TENDER ADDENDUM

Project:	UHN Interventional Fluoroscopy Replacement University Hospital of Northern British Columbia 1475 Edmonton Street, Prince George, BC V2M 1S2	Tender Addendum #:	02
		DCTYA Project #:	2009
		NHA Project #:	N662050005
		Issued By:	Douglas Cheung
To:	All Bidders	Issue Date:	Feb 26, 2021
Copies To:	Leah Joseph / Northern Health Authority

STRUCTURAL ADDENDUM No. 2

Project: UHN Fluoroscopy Replacement **File:** 11815
Architect: DCYT Architecture, Douglas Cheung **Date:** February 26, 2021

S11r 2 Phase 1 - Inter Fluoro - Roof & Penthouse Plans & Sections

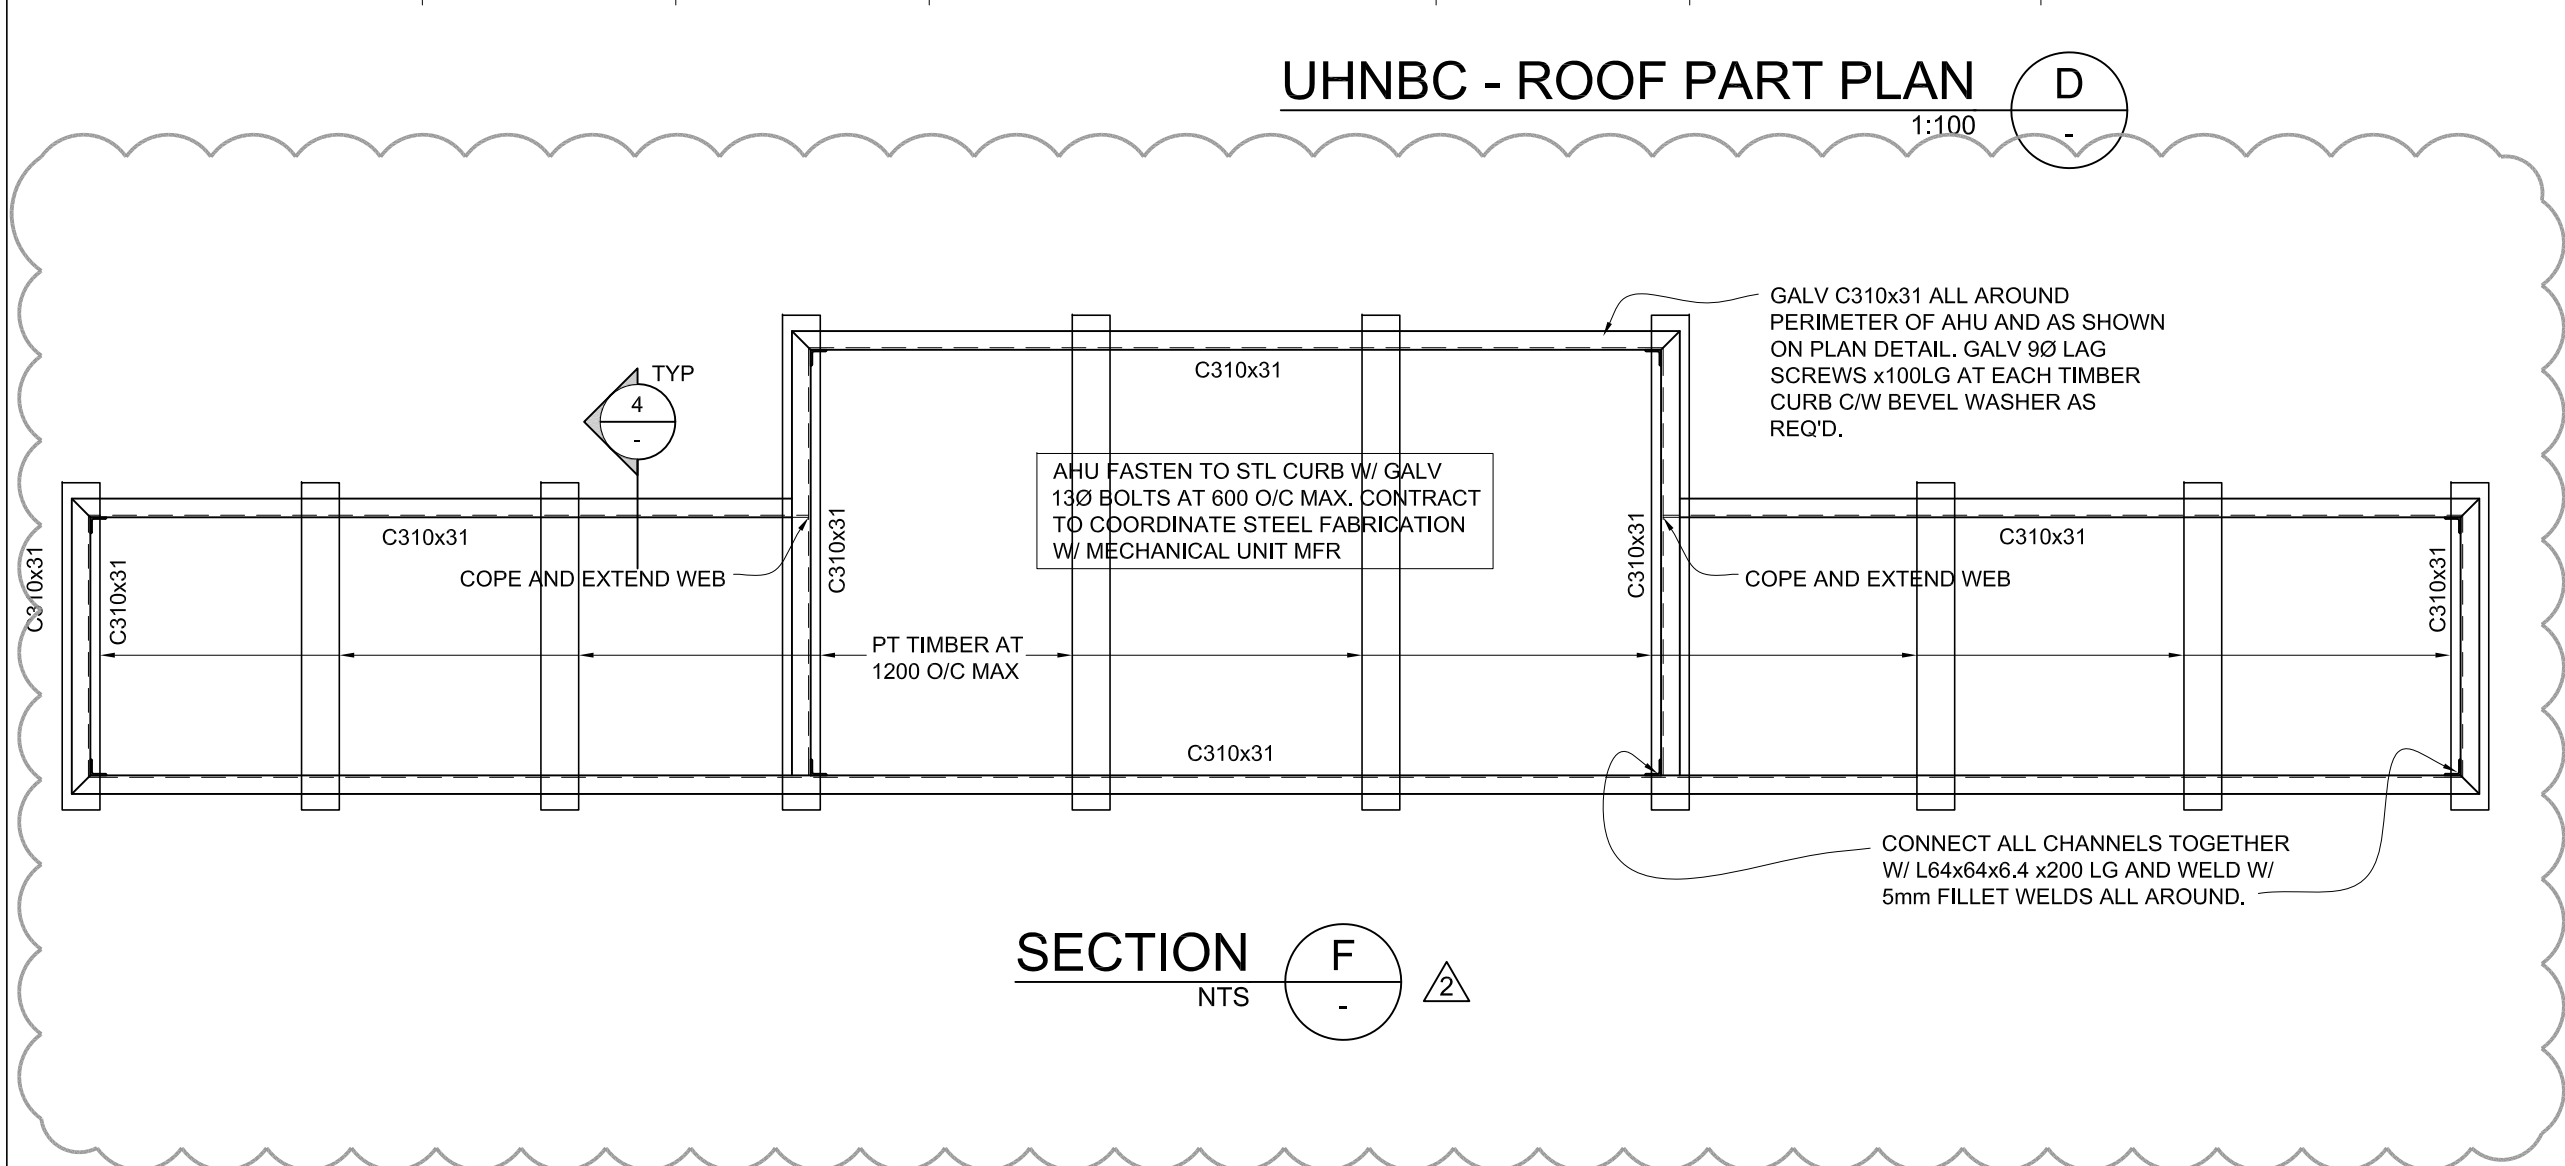
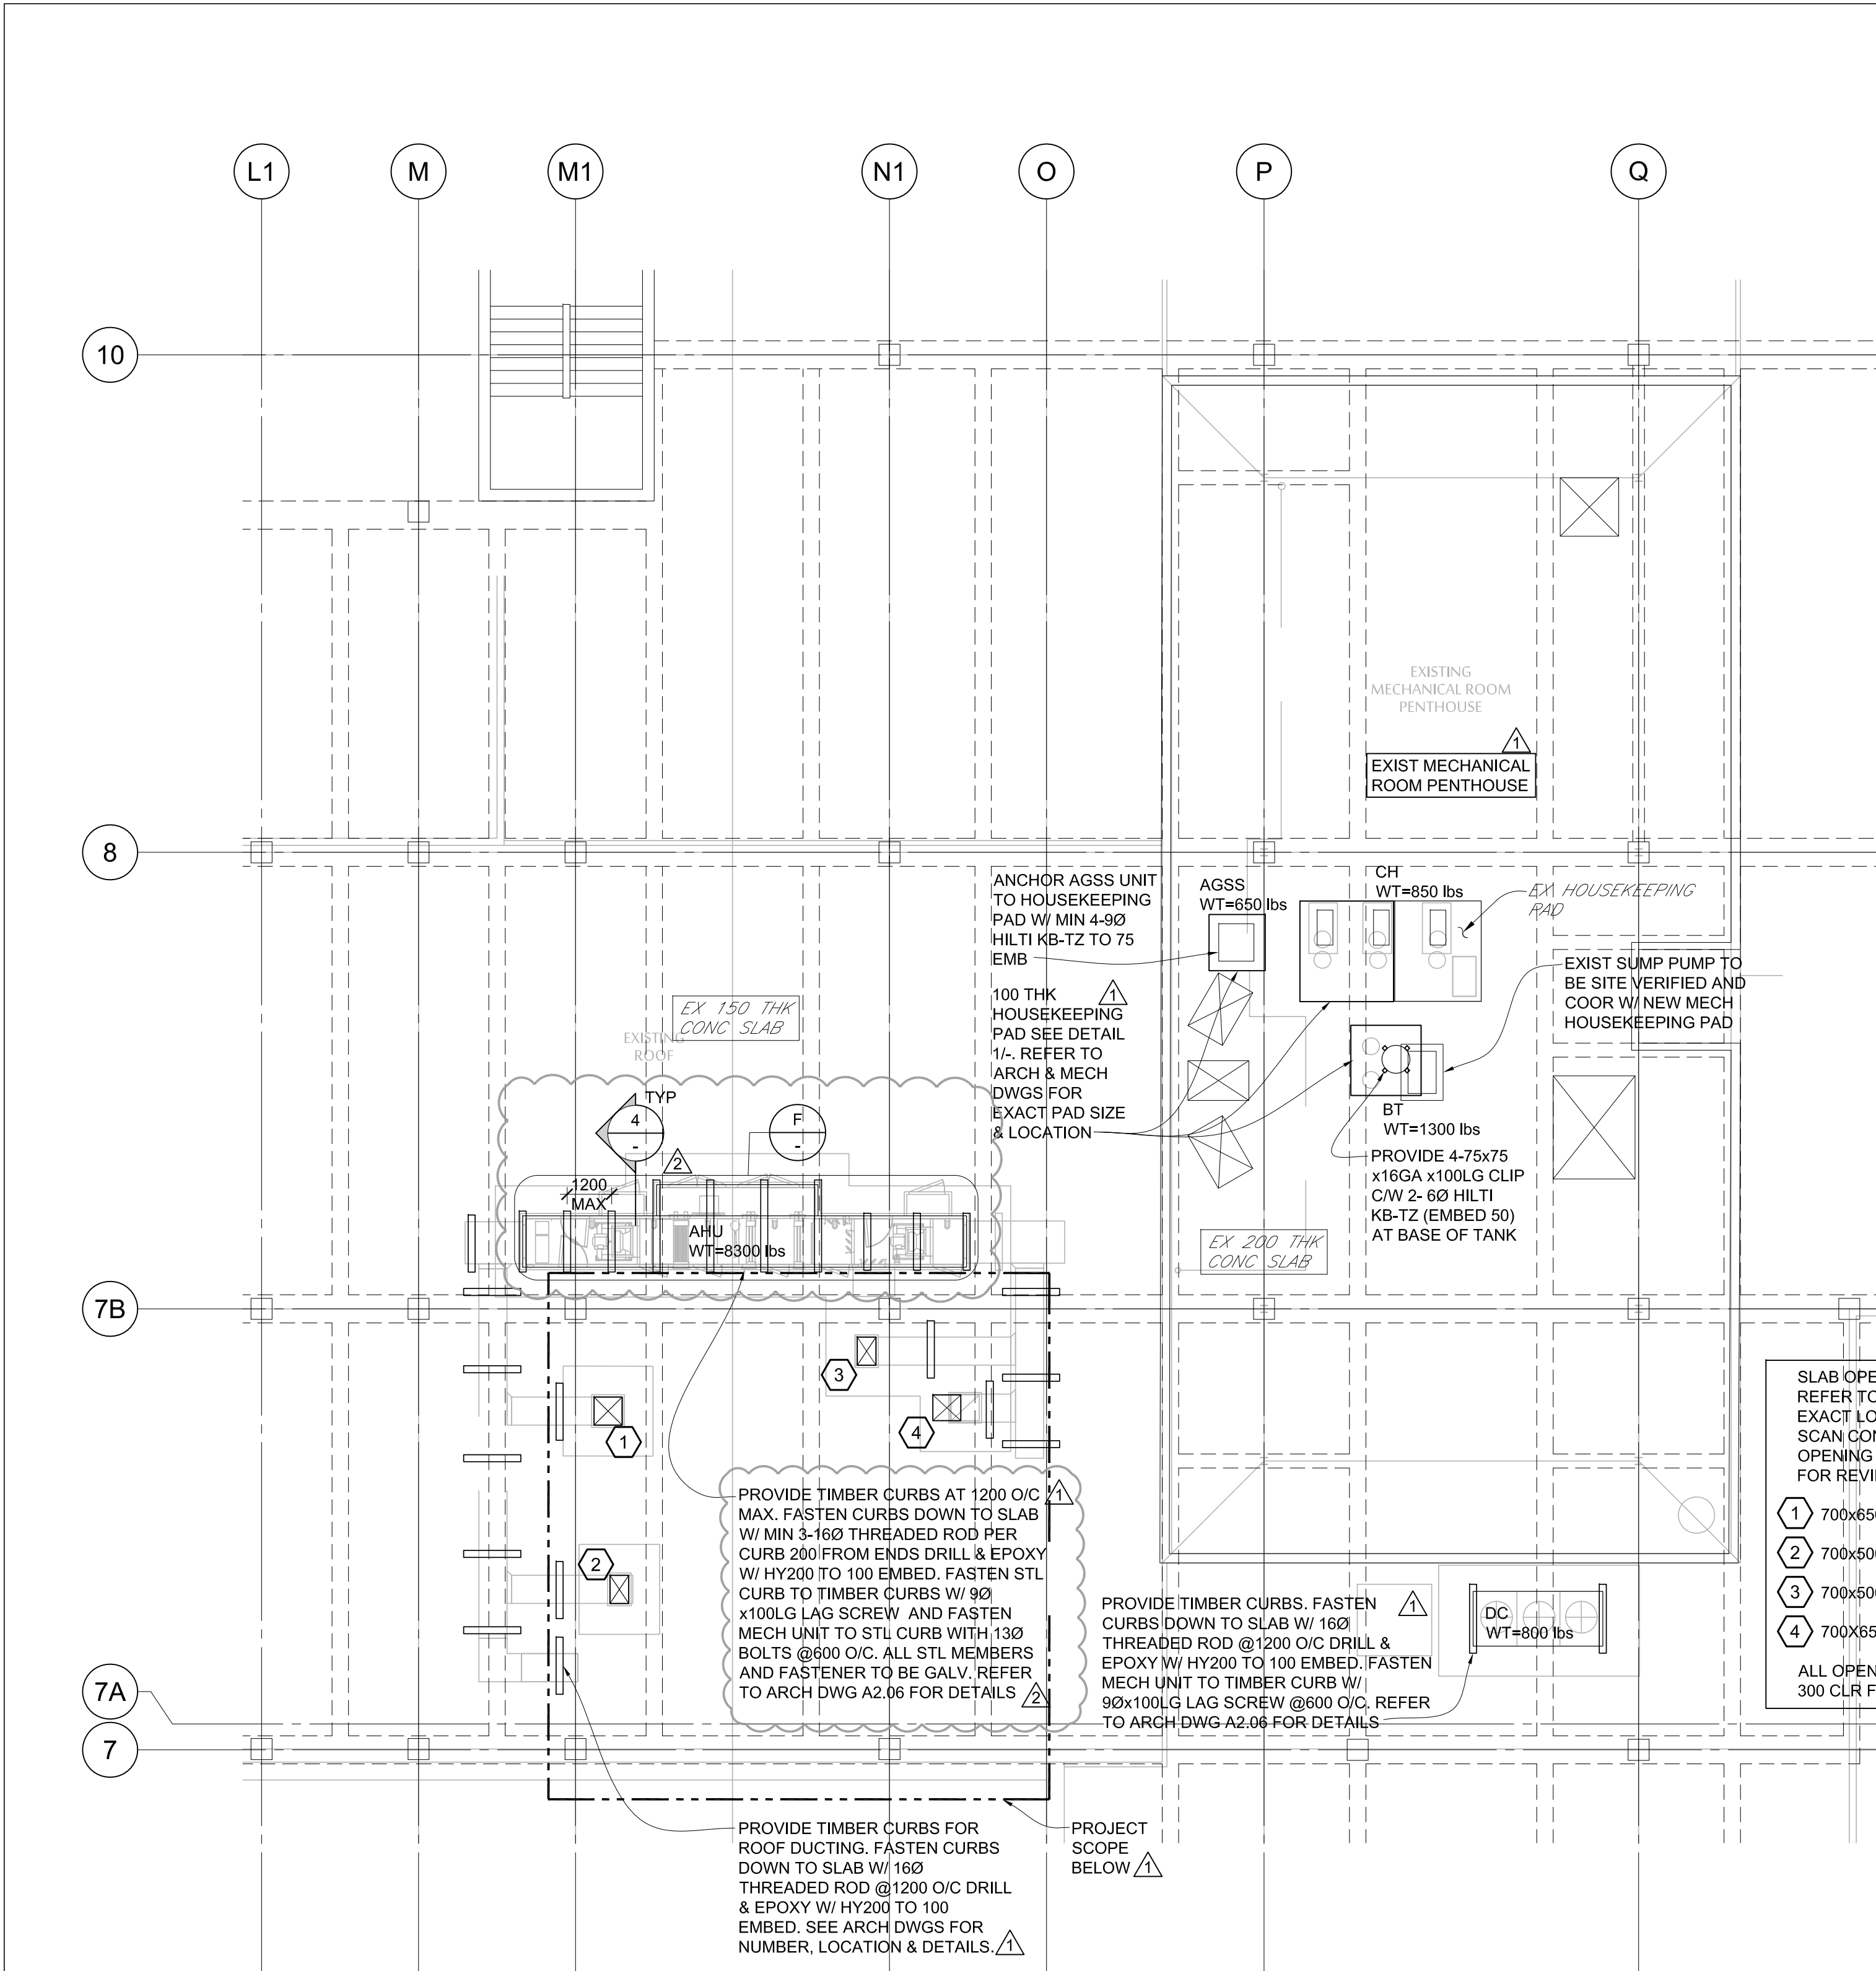
REVISIONS TO DRAWINGS**ITEM DWG. REVISION TO DRAWING / SPECIFICATION****1 S11 PHASE 1 - INTER FLUORO - ROOF & PENTHOUSE PLANS & SECTIONS**

- 1 On roof plan, change continuous AHU timber curb to timber curbs spaced at 1200mm on center and adjust notes to match as shown on S11 attached.
- 2 Add detail F and section 4 to show extent of pressure treated timber curbs and structural steel C310x31 curb around perimeter of AHU unit. All steel and fasteners to be hot dip galvanized as noted on details.
- 3 On penthouse roof plan, adjust existing roof framing based on site photos as existing framing does not match existing drawings. Framing is to be confirmed by the contractor on site prior to fabrication of medical gas exhaust support structure. Adjust support structure location to suit site conditions as shown on S11 attached.
- 4 Detail 2 and 3 revised to suit site conditions. Change vertical steel pipe size to 141mm outside diameter and extend to penthouse floor slab.

1. Drawing #E2.01

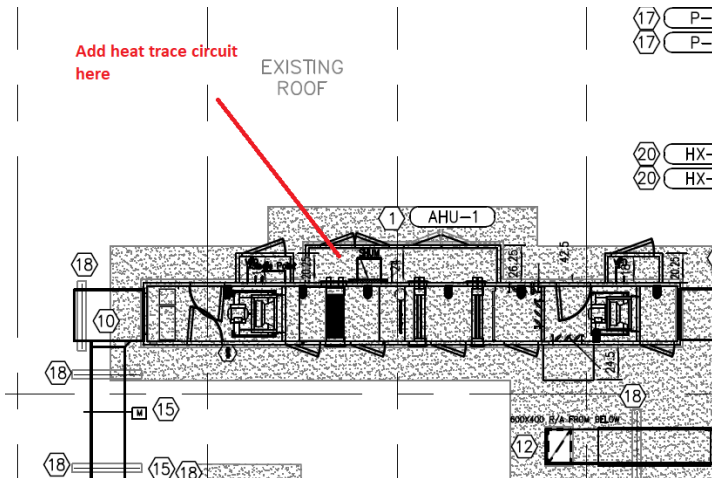
- a. Specification for Light Fixtures LF01, LF02 and LF04 has changed.

- b. The alternate lighting package from Symmetry Lighting has been reviewed and is acceptable, along with the N-Light lighting controls.
- c. The colour temperature lighting control is to adjust the colour temperature of all LF01, LF02 and LF04 fixtures on dimming circuits a,b,c.
